Serial No.: 11-390  
NLOS/TJS: R0  
Docket No.: 50-305  
License No.: DPR-43

**DOMINION ENERGY KEWAUNEE, INC.**  
**KEWAUNEE POWER STATION**  
**REVISION TO KEWAUNEE POWER STATION EMERGENCY PLAN**

**Kewaunee Power Station  
Emergency Plan  
Revision 36  
June 30, 2011**

## Revision Summary

**FIGURE 2-1  
Interrelationship Of Overall Emergency Response Organization**

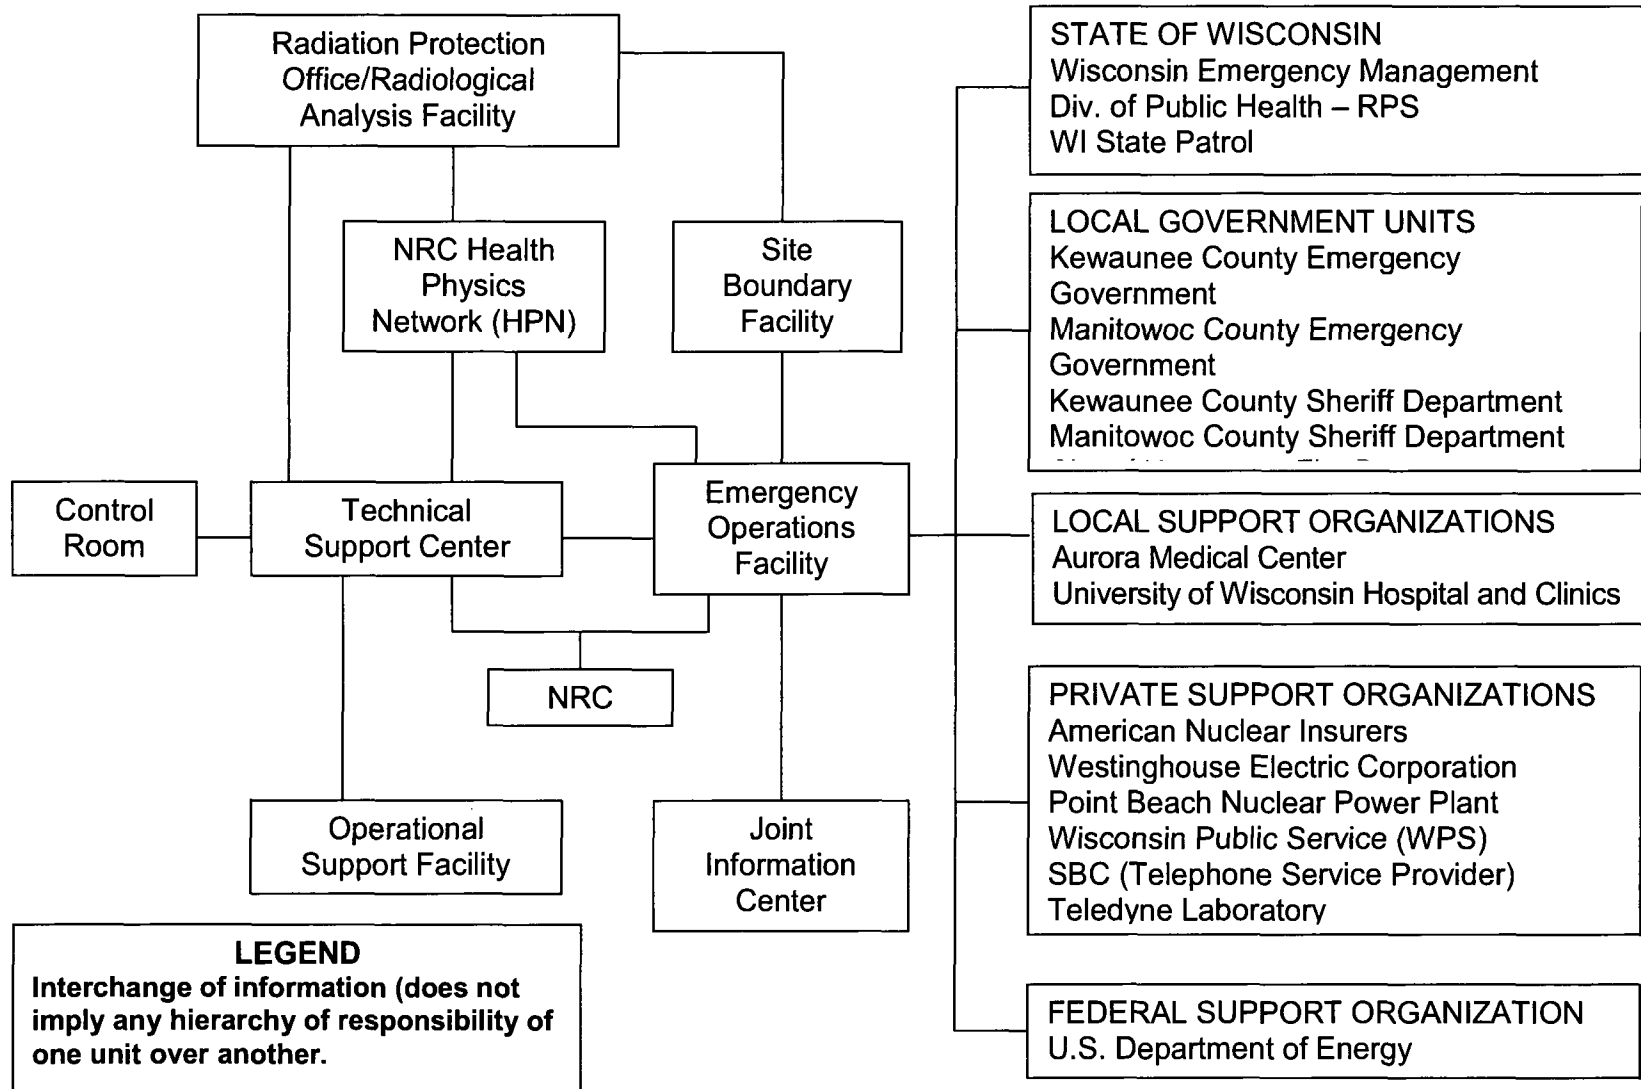
1.1 and 2.2.1	Nuclear Administrative Directives (NAD)	Administrative Procedures	Dominion Fleet administrative procedures have replaced the NADs.
Figure 2.1	HPN was shown as connected to RPO/RAF only	HPN shown connected to RPO/RAF, TSC, and EOF	HPN Phones are located in each of these facilities.

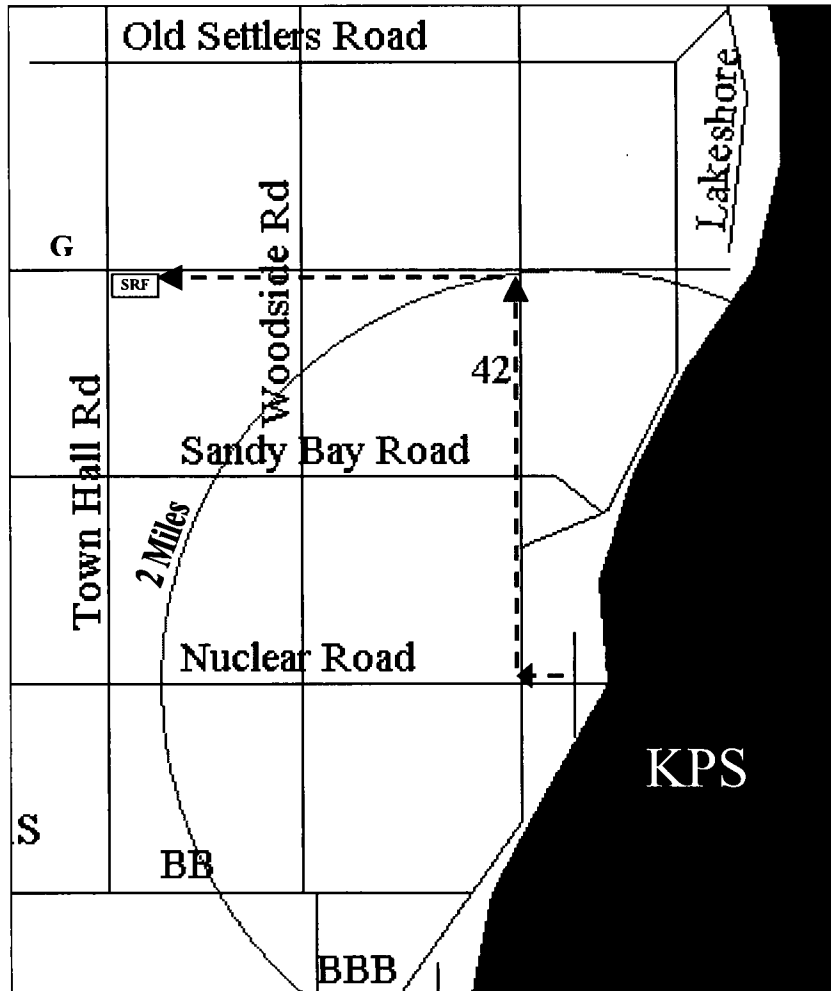
7.1	(see Appendix C, pages C-2 and C-6 for locations).	(see Appendix C, pages C-2, C-6 and C-7 for locations).	Page C-7 shows the location of the SRF.
8.3.1	NAD-05.15, "Revision and Control of the Emergency Plan and Emergency Action Levels,"	EP-AA-102, "Revision and Control of the Emergency Plan, Emergency Action Levels (Technical Basis and Matrix) and Reference Manual."	Fleet procedure EP-AA-102 has replaced NAD-05.15.
Various	Cross - Reference	Cross-reference	Minor format correction.
Appendix D Page D-2	G., WPSC Eastern Region, Emergency Plan Files	None	This is an obsolete agreement for the use of a WPS building by the State for power to the mobile lab. The State now uses the Armory for this purpose.
Appendix D Page D-2	Services Agreement between WPSC and Dominion*, Dominion Corp. Supply Chain	None	This is an obsolete agreement for the use of a WPS building in Green Bay for the KPS EOF. New EOF has been built for KPS.
